<b>TO:</b>	<b>Dr. Cone,</b> Superintendent of Schools, LVISD	<b>FROM:</b>	<b>Catherine Blackler</b> <i>Catherine Blackler</i> Senior Project Manager, AGCM
<b>cc:</b>	Belinda Raindl, LVISD		Michael Rogers, AGCM
<b>RE:</b>	La Vernia ISD – Bond 2023	<b>DATE:</b>	June 18, 2025
<b>SUBJECT:</b>	PR No. 06	<b>PR DATE:</b>	April 03, 2025
<b>PR COST:</b>	\$ 11,133.00	<b>CONTRACTOR:</b>	Bartlett Cocke (RCO 15)

Description **PR#6** - Unforeseen Cavity Fill at PKG 1 Bus Drive Date 2025-05-12  
Status: Pending Review Days Impact:

**AIA**<sup>®</sup>**Document G709™ – 2018****Proposal Request****PROJECT:** *(name and address)*  
La Vernia ISD 2023 Bond 22-075**CONTRACT INFORMATION:**  
Contract For:Architect's Project Number: 22-075  
Proposal Request Number: 6Date:  
04-03-2025

**SUBJECT:** Unforeseen Condition: Primary / Intermediate - Void beneath the Concrete Drive

**Unforeseen Condition:**  
**02.06.25**  
**Void beneath Concrete Drive**  
**Primary and Intermediate**

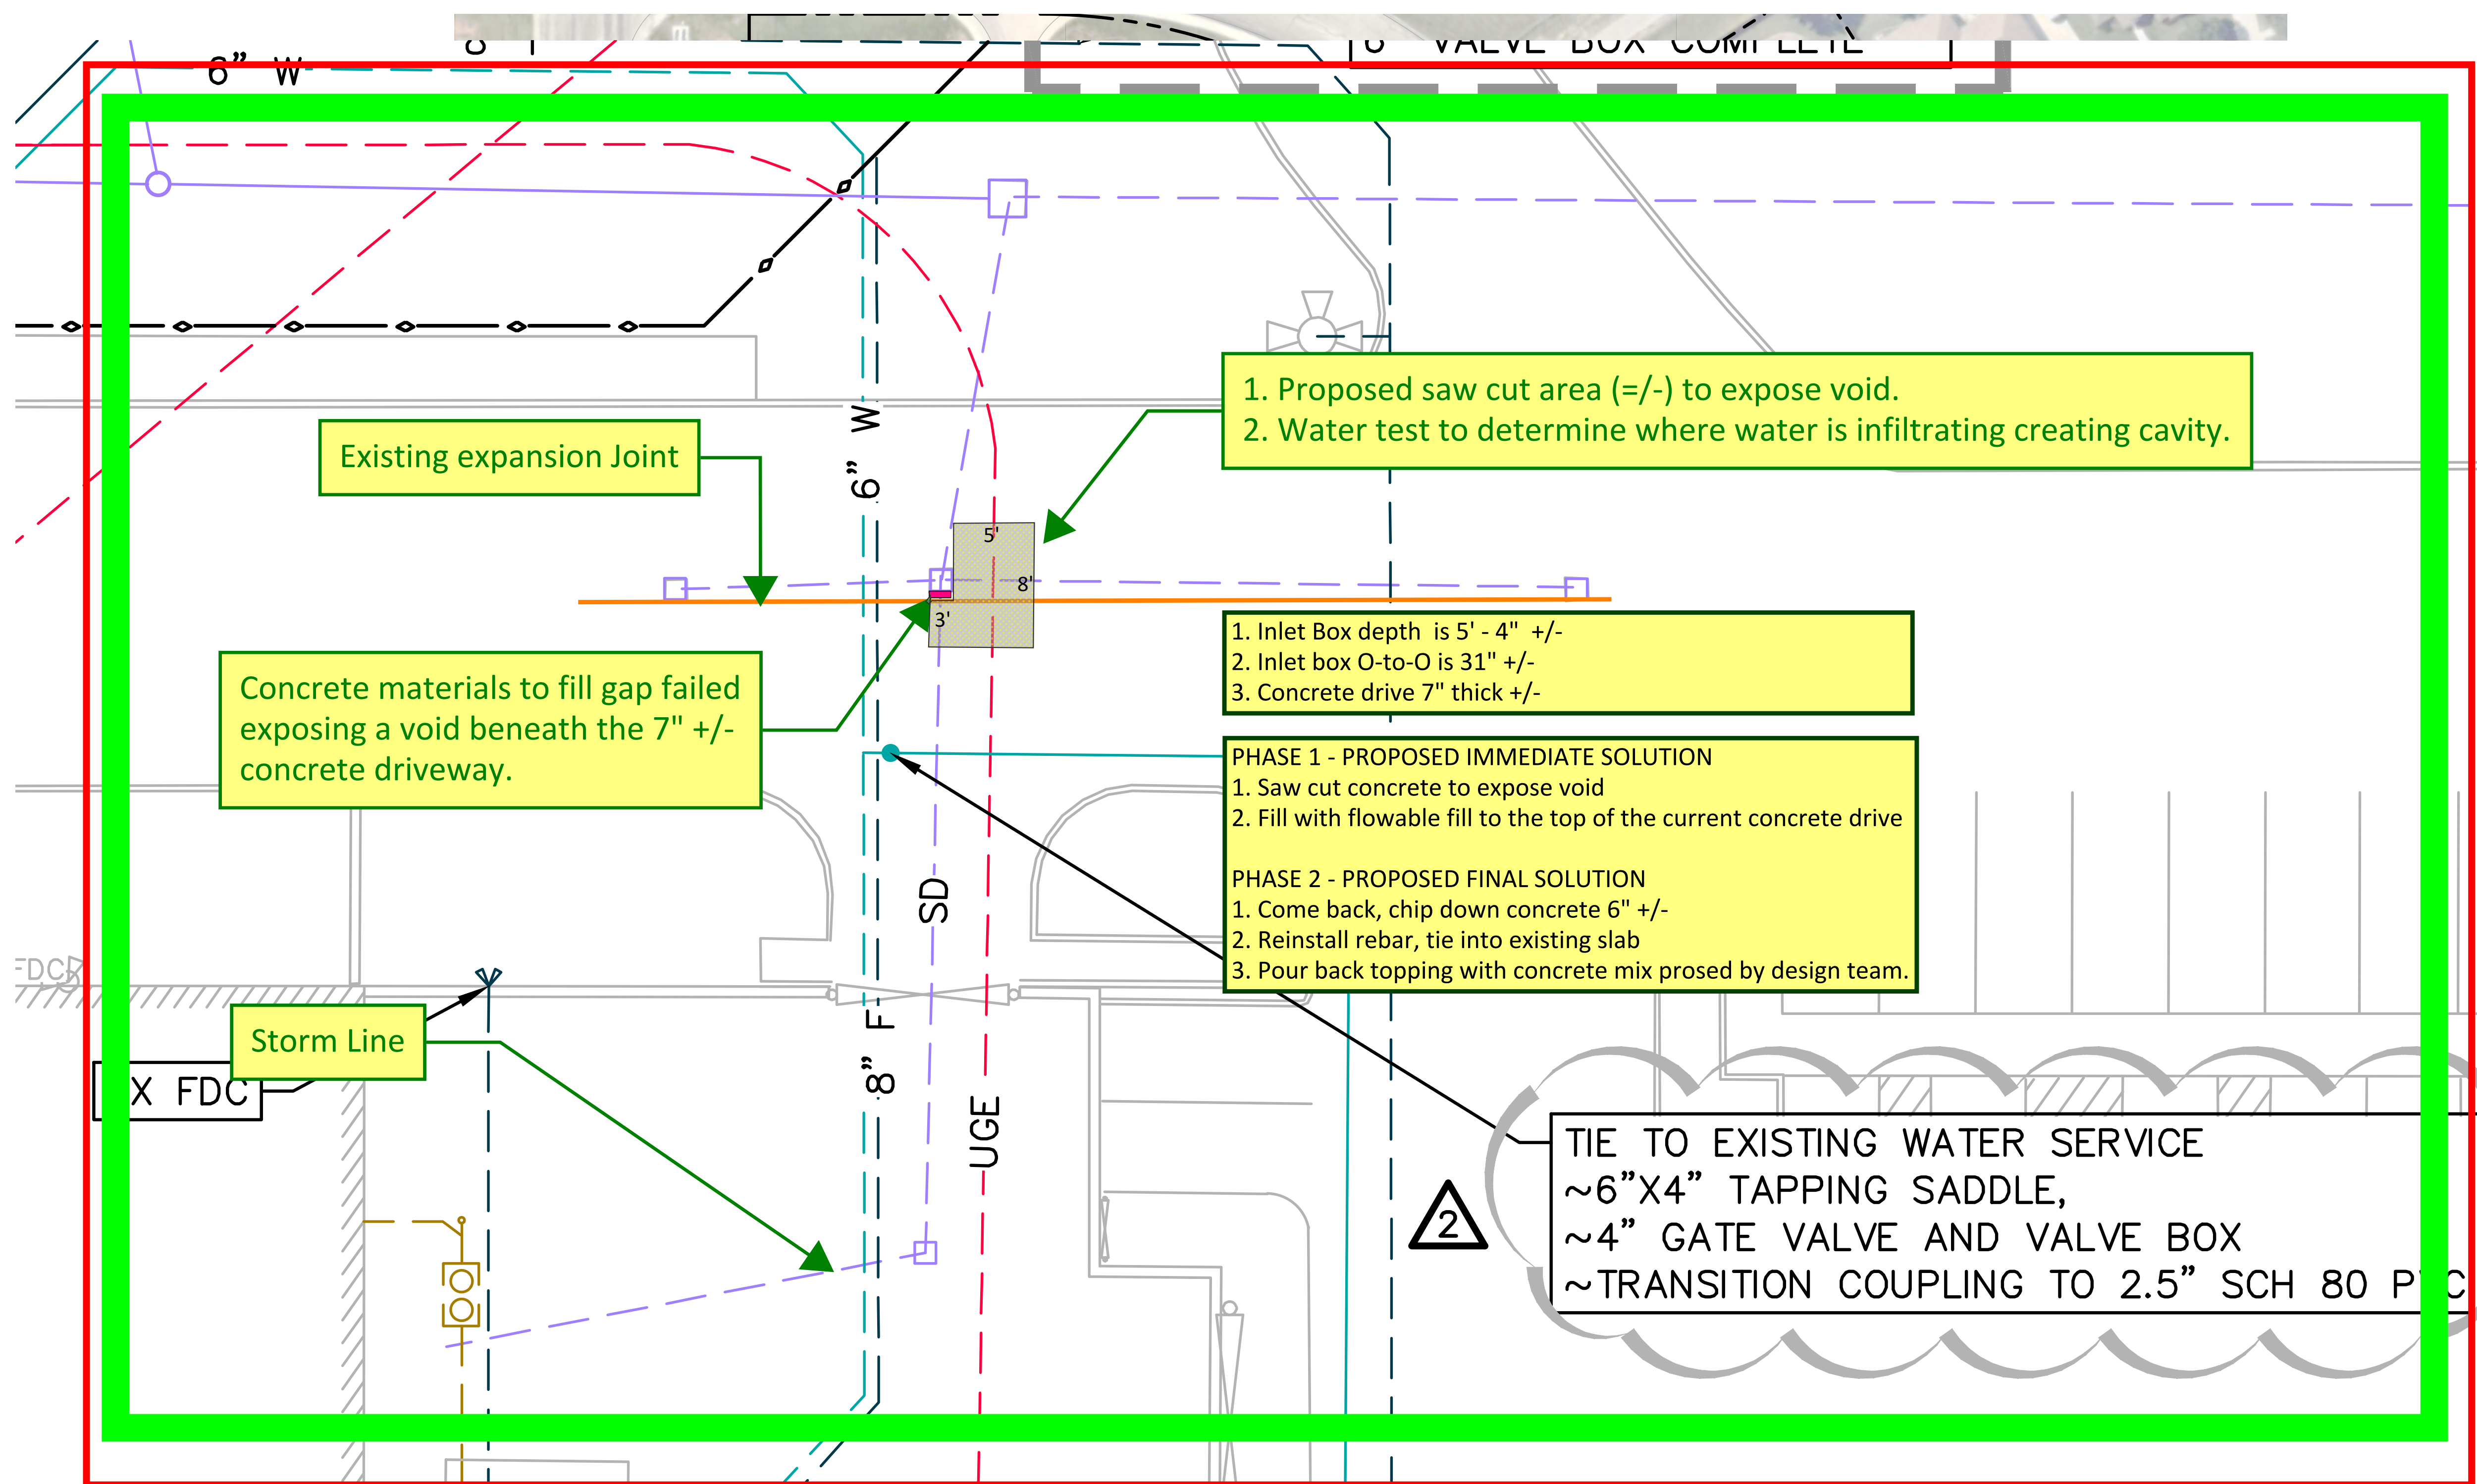
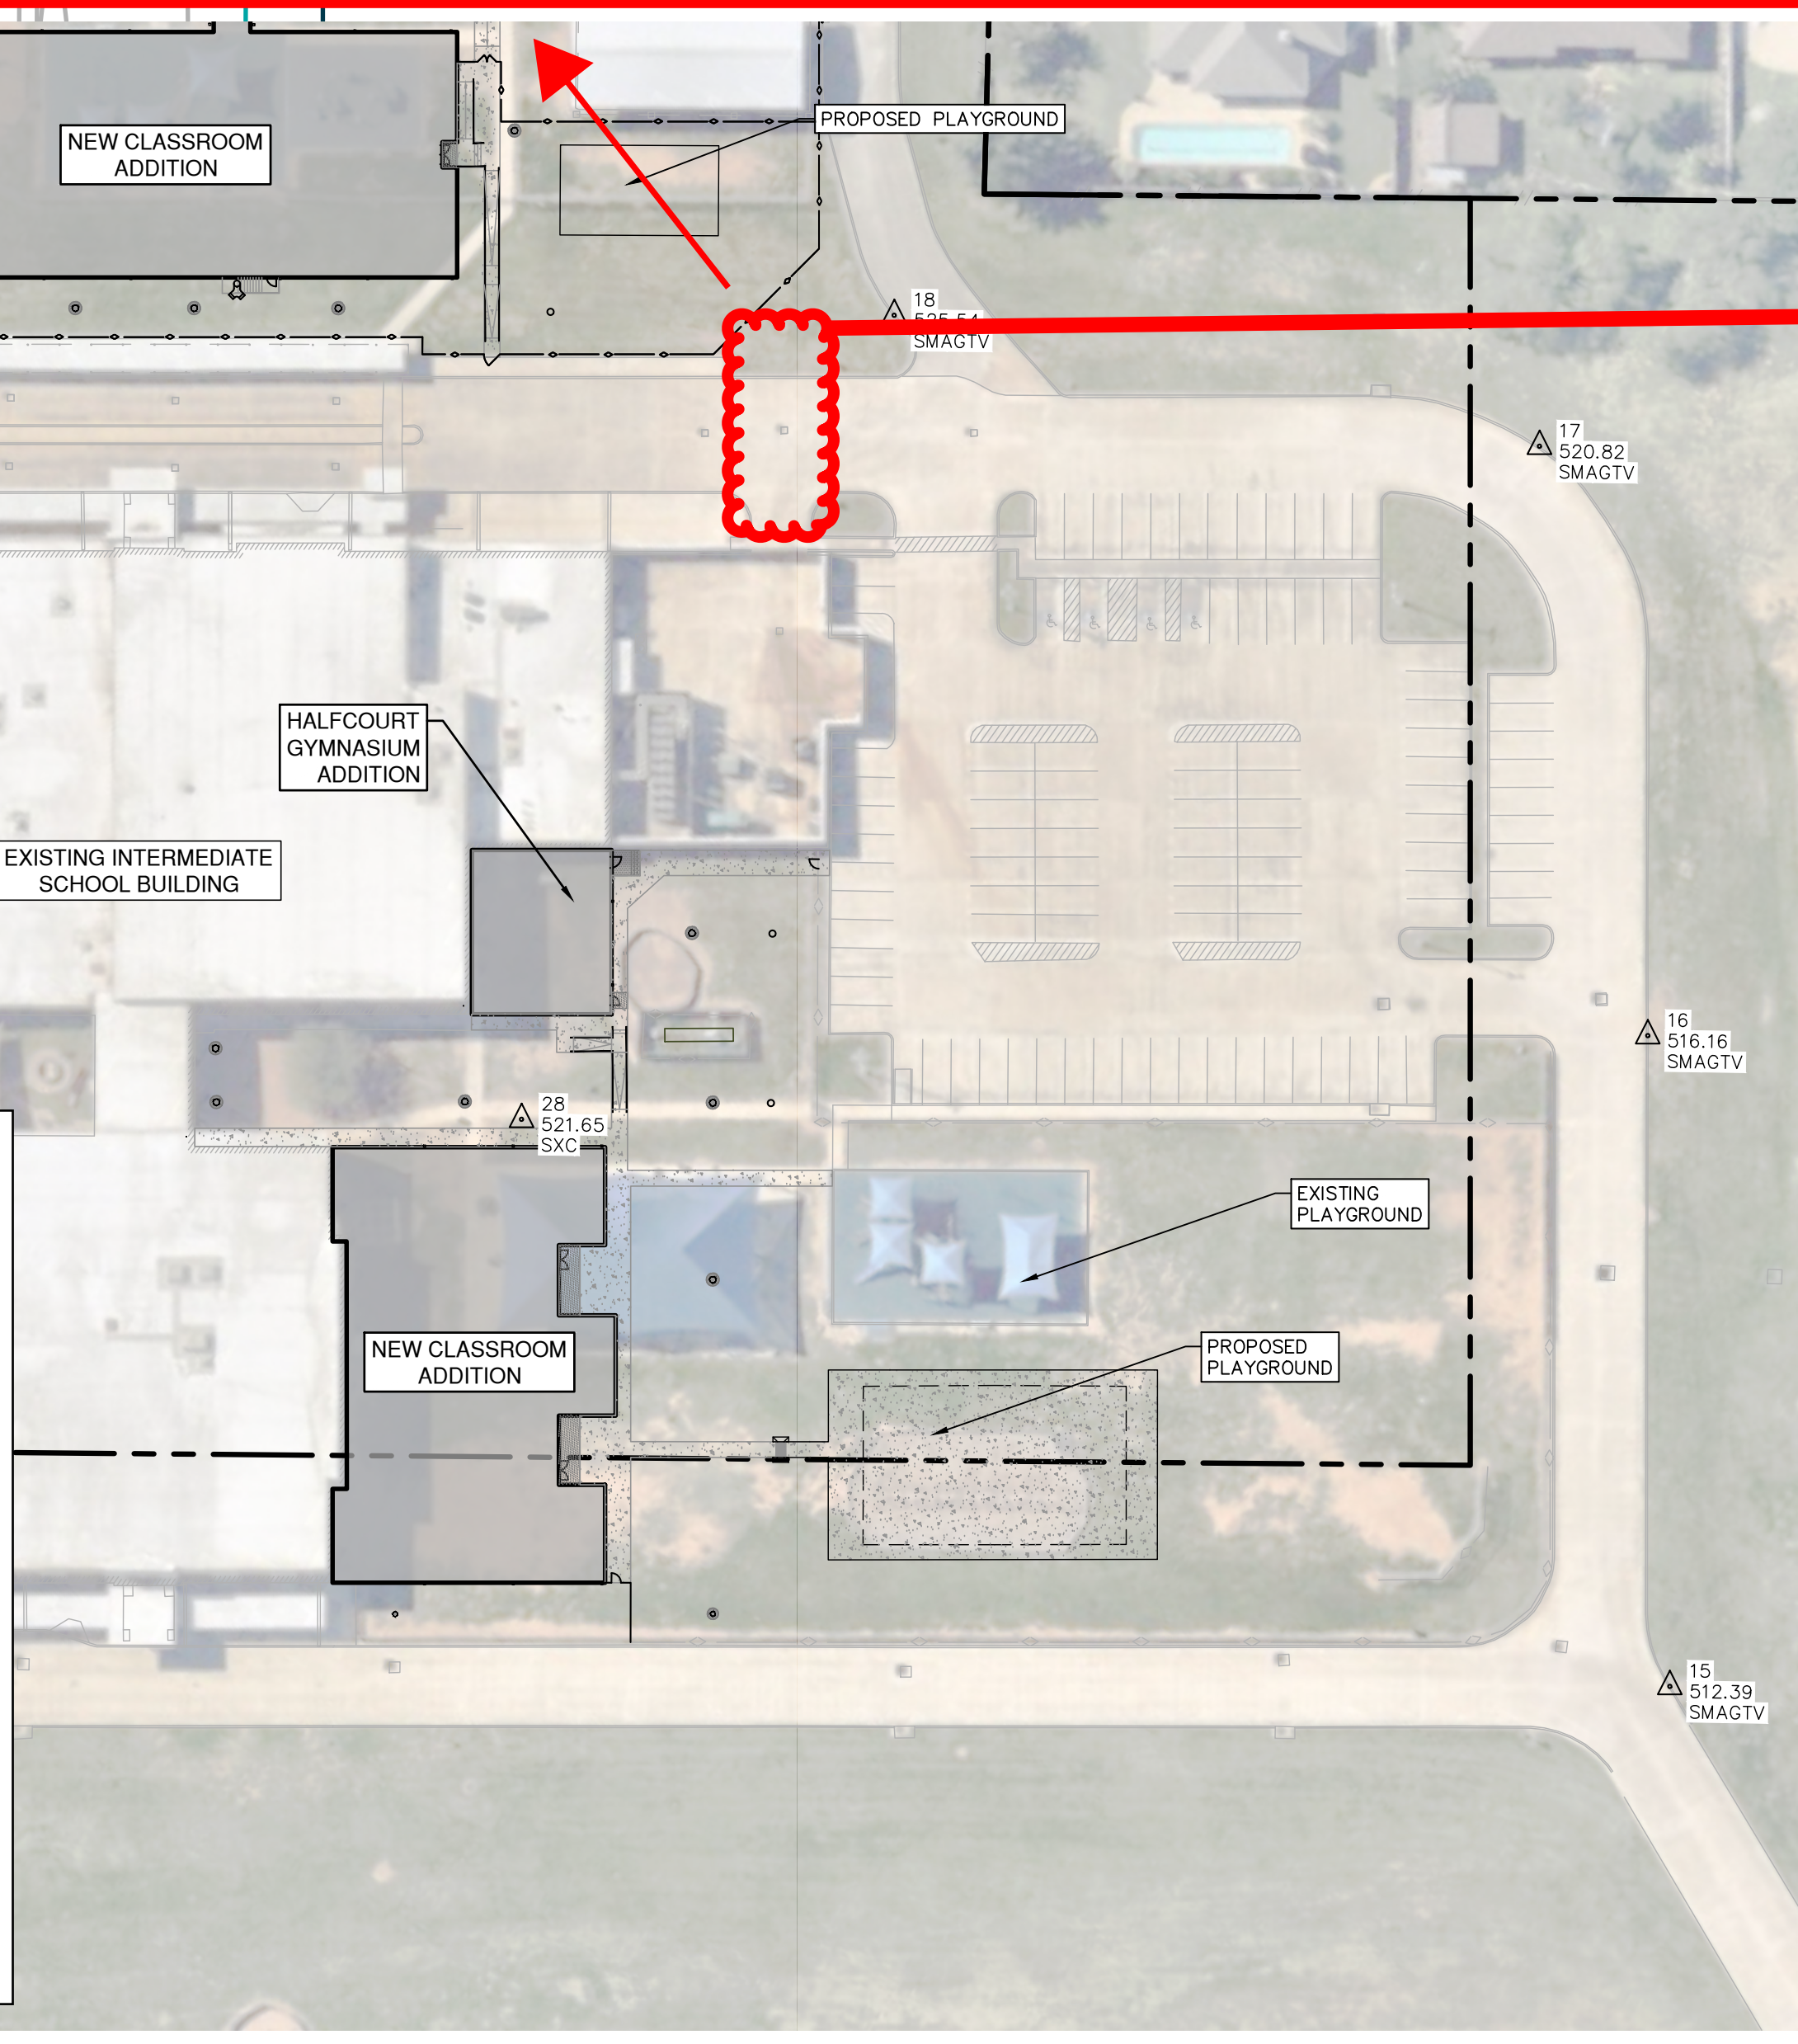
Bartlett Cocke notified AGCM today of an unforeseen condition. A void was observed beneath the concrete drive between the Primary (PRI) and the Intermediate (INT) areas. The cavity is located at the middle inlet box installed in front of the entry to the mechanical yard.

- **Expansion Joint:** An expansion joint runs along the center of the concrete driveway.
- **Inlet Boxes Positioning:** The north and south inlet boxes are positioned up against the expansion joint.
- **Middle Inlet Box:** The middle inlet box is installed approximately 2" (+/-) from the expansion joint, creating a gap between the inlet box and the joint.
- **Concrete Encasing:** It appears that the original concrete poured did not fully encase the inlet box or properly align with the expansion joint, resulting in a gap that seems to have been filled with a concrete-like material.
- **Slab Thickness:** The slab appears to be approximately 7" thick (+/-).
- **Inlet Box Dimensions:** The inlet box measures approximately 2' - 7" outside to outside and has a depth of approximately 5' - 4".
- **Slab Condition:** No visible fractures were observed on the top of the slab.

- **Base Erosion:** The base beneath the concrete driveway has eroded, likely contributing to the failure of the concrete patch.

- **Utility Camera Inspection:** A site utility camera was used to determine the size of the cavity. However, the exact area of the cavity remains unknown until further exploration is conducted.
- **Cavity Estimation:** Based on what could be assessed, the estimated area of the cavity is assumed to be approximately 50-54 square feet, with a depth ranging from 3'- 5' (+/-).

- **Steel Plate Installation:** Bartlett Cocke provided a 5' x 5' x 3/4" steel plate, positioned over the area where the cavity is anticipated.

- **Saw Cutting:** Saw cut the concrete driveway (refer to the attached plan for location and approximate size).
- **Expose the Cavity:** Expose the cavity to assess the extent of the issue.
- **Water Testing:** Conduct water testing on the storm line/area to determine the cause of the initial erosion.
- **Cavity Fill:** Fill the cavity with flowable fill up to the level of the concrete driveway.
- **Concrete Work:** At a later stage, during concrete site work, revisit the area to remove 6"/7" of the flowable fill, dowel into the existing slab, add rebar and pour the new concrete according to the strength specifications approved by the design team.
- **Timing:** Bartlett Cocke anticipates performing the corrective work over Spring Break to minimize impact on bus routes. Further discussion with the district and campus is necessary.
